**Technical Service  
BULLETIN**

Title:  
**ACCESS DOOR WATER LEAK**  
Models:  
**'07 FJ Cruiser**

**BODY**  
**B0007-07**

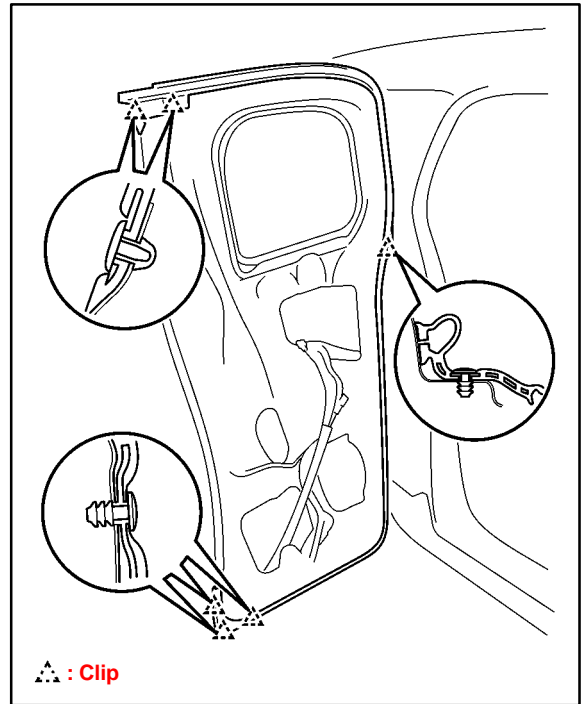
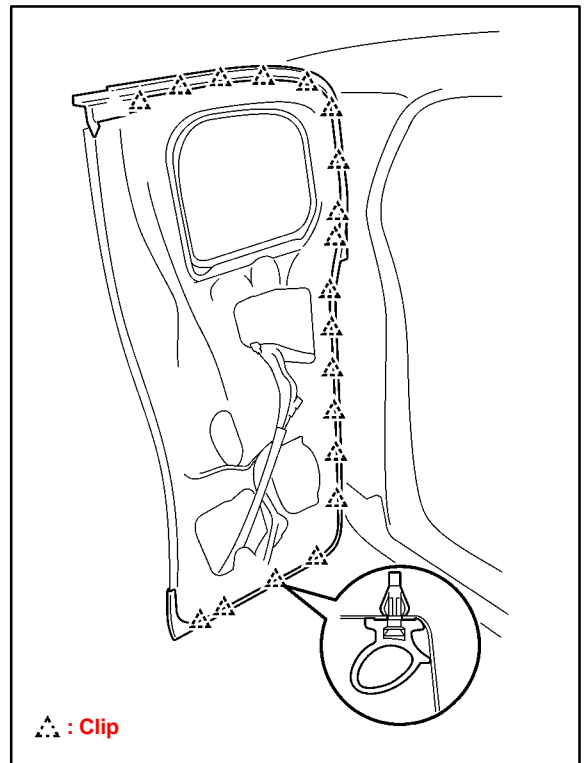
1. Remove the access panel weatherstrip.
  - A. Disengage the 7 push clips.

- B. Using the plastic panel clip removal tool, disengage the 19 clips on the weatherstrip.

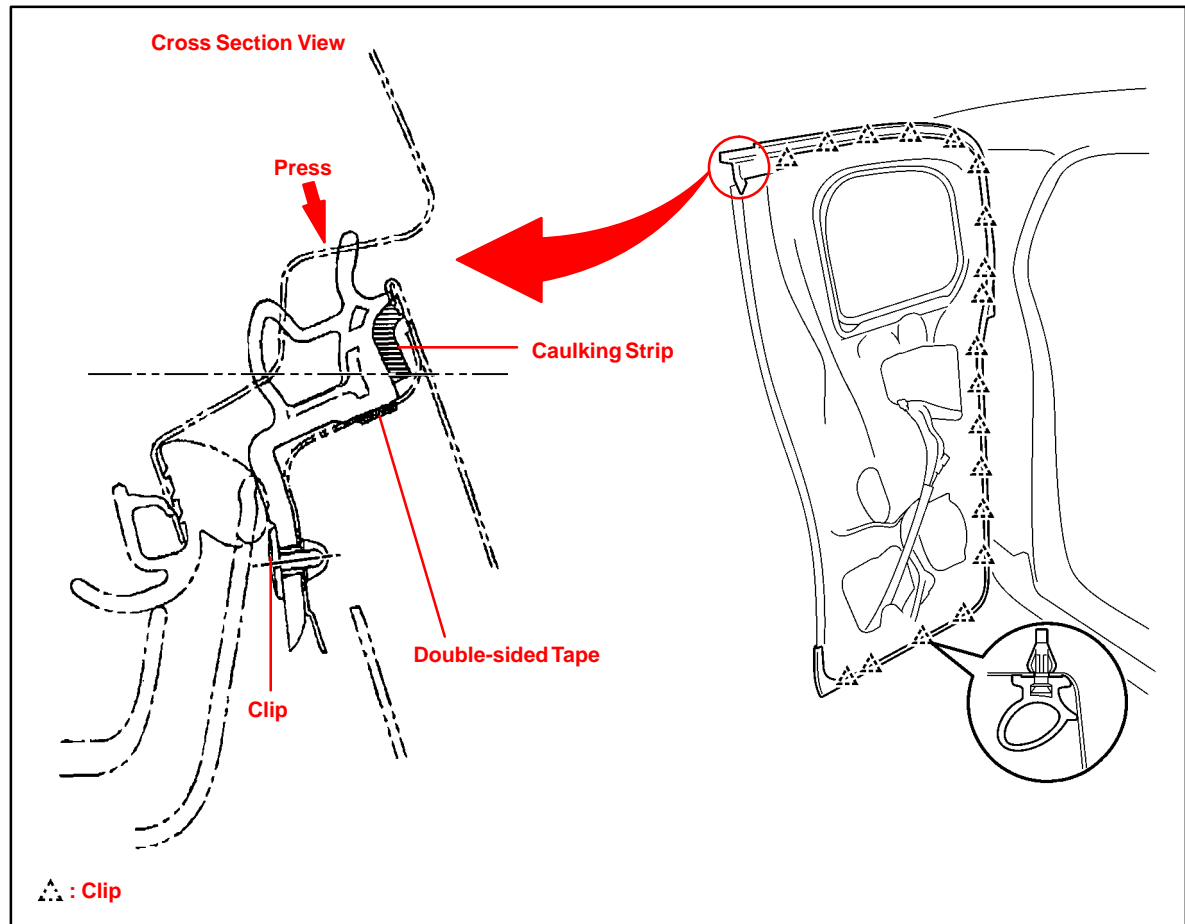
2. Install the access panel weatherstrip using the NEW service parts.
  - A. Clean the door surface where the double-sided tape is applied.
  - B. Engage the 19 clips.
  - C. Push firmly on the weatherstrip to ensure the double-sided tape makes good contact with the door frame.
